Docket Item # 1
BAR CASE # 2014-00412

BAR Meeting
January 7, 2014

ISSUE: Certificate of Appropriateness and Waiver of HVAC Rooftop Screening Requirement

LOCATION: 212 King Street

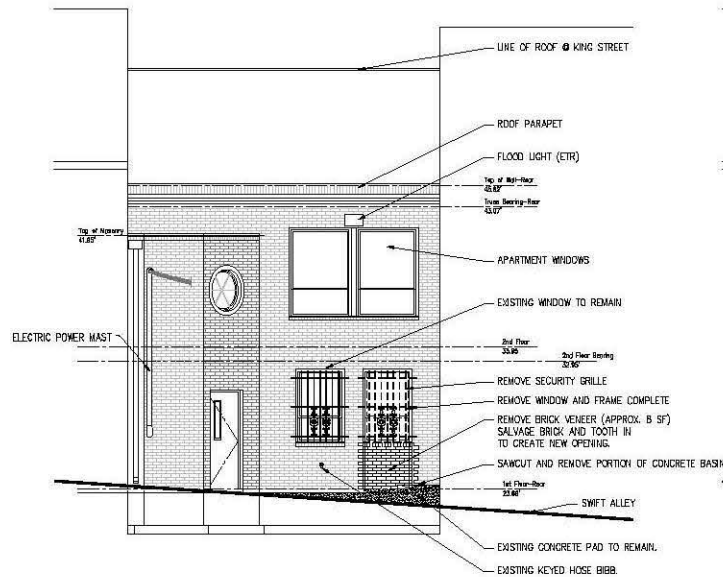
The proposed rooftop mechanical equipment is not visible, however, section 6-403(B)(1) of the zoning ordinance requires screening of rooftop mechanical equipment, regardless of visibility. The Board has consistently waived the screening requirement on rooftop locations that are not visible to pedestrians from a public way, as this is consistent with the *Design Guidelines* on HVAC, and Staff recommends approval of the waiver. For the reasons stated above, Staff recommends approval of the Certificate of Appropriateness, as submitted.

**Rear Exterior Building Elevation
Demolition and Notes**

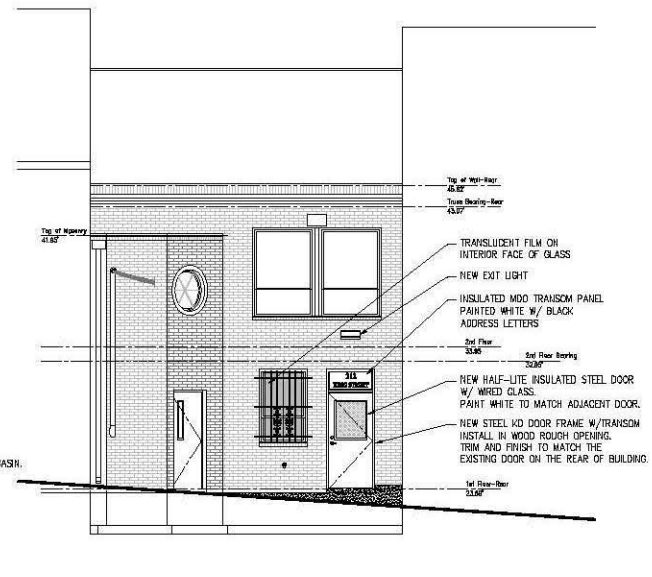
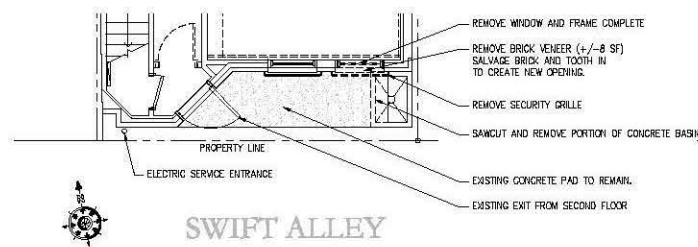
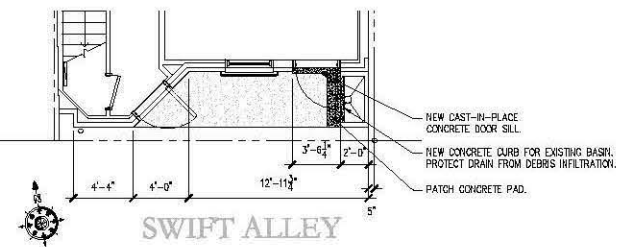
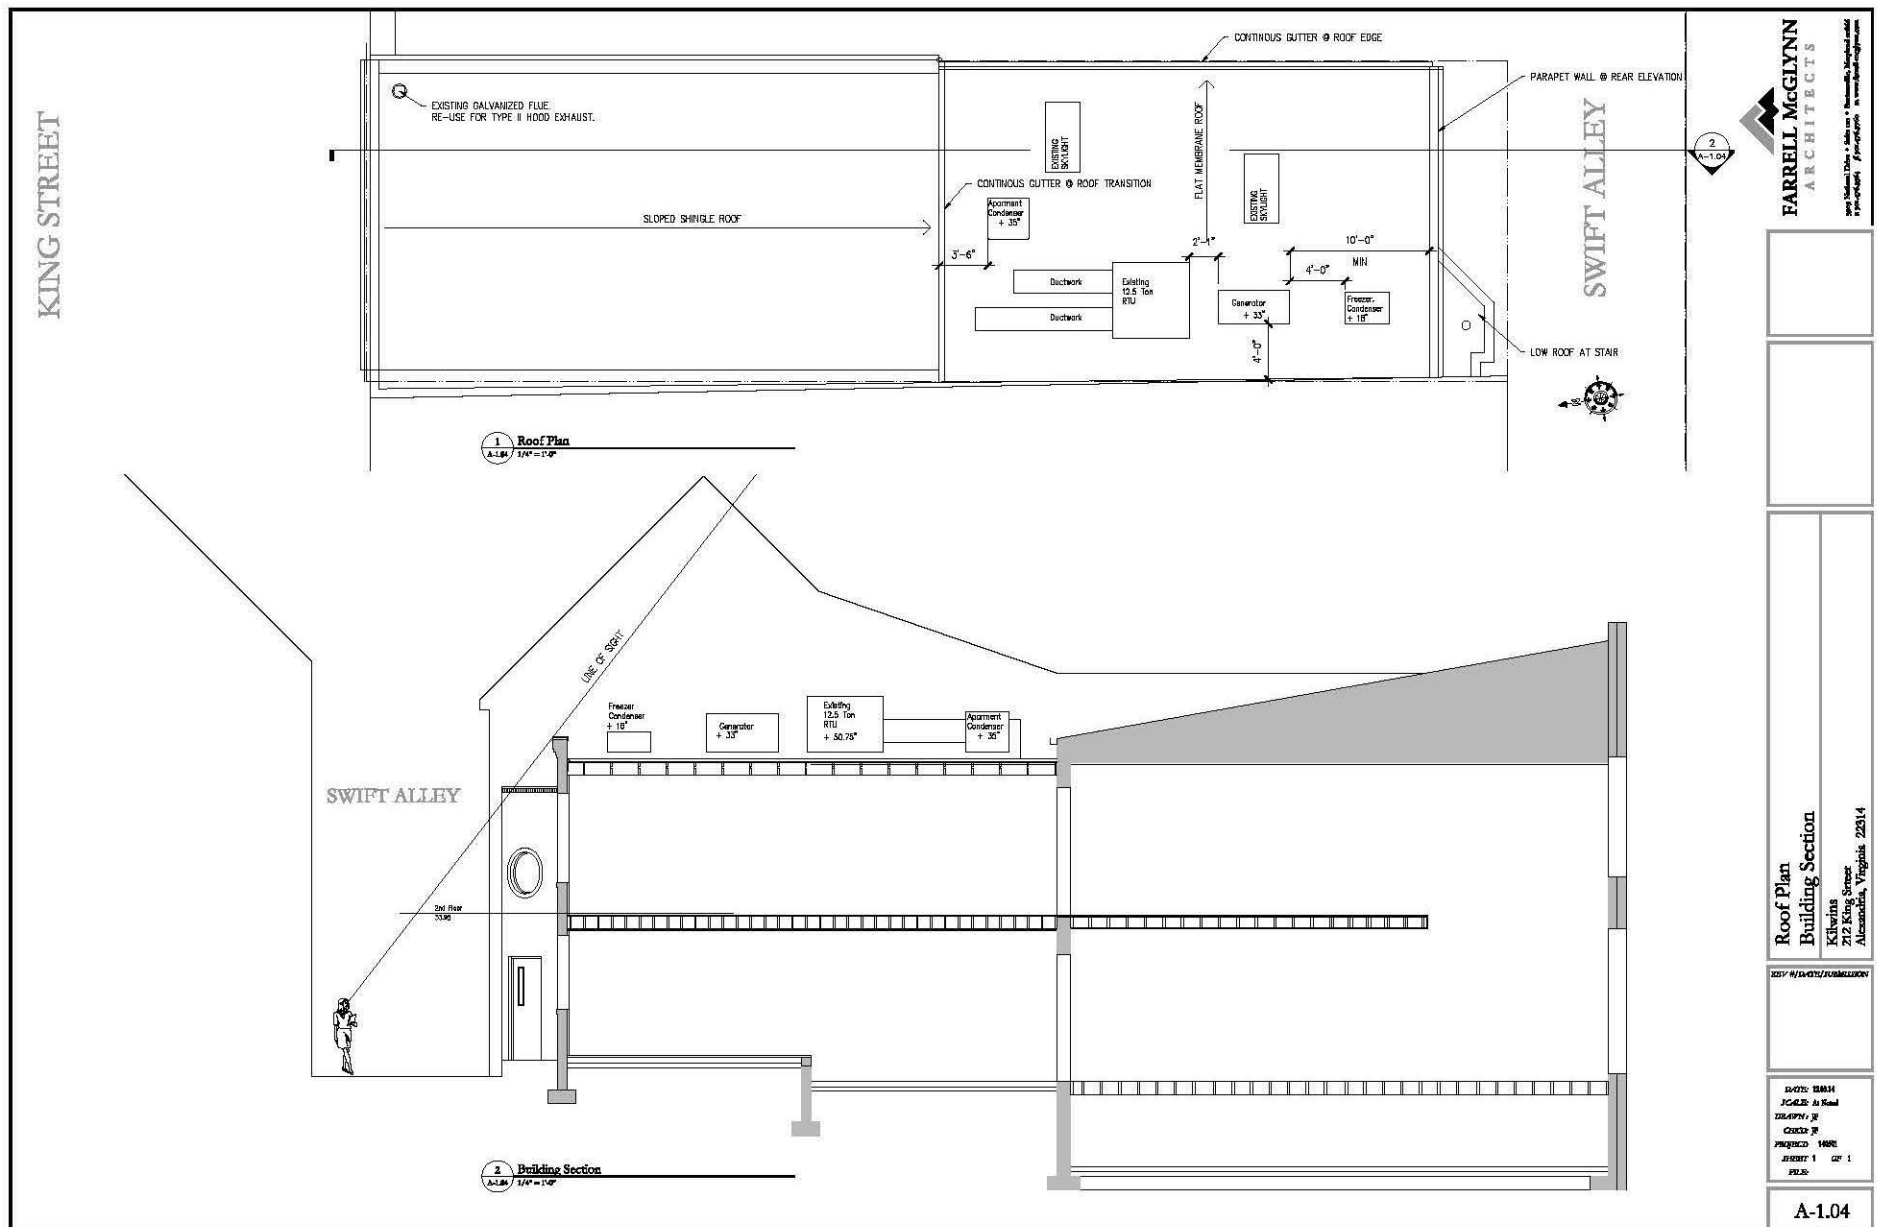
The *Design Guidelines for Doors* state that, “exterior flush or paneled metal doors may be appropriate in certain limited circumstances for 20th century retail, commercial, and industrial buildings”. Staff finds the half-light steel door with security glass stylistically appropriate for a rear service door on the 1979 addition. While security wire glass is not something typically proposed in the historic district, Staff notes that it will be virtually impossible to discern from S. Fairfax Street and is visually less obtrusive than metal security bars. Staff has no objection to the removal of the non-historic masonry and window to make such an opening.

Staff suggests that the proposed transom contain glass, either clear or frosted, as opposed to MDO – a treated plywood material that is often used for signs along King Street. Opaque window coverings are not consistent with the *BAR Window Policy* or *Design Guidelines*, due to the limited visibility and utilitarian purpose of the rear façade, Staff leaves this only as a suggestion, not a recommendation.
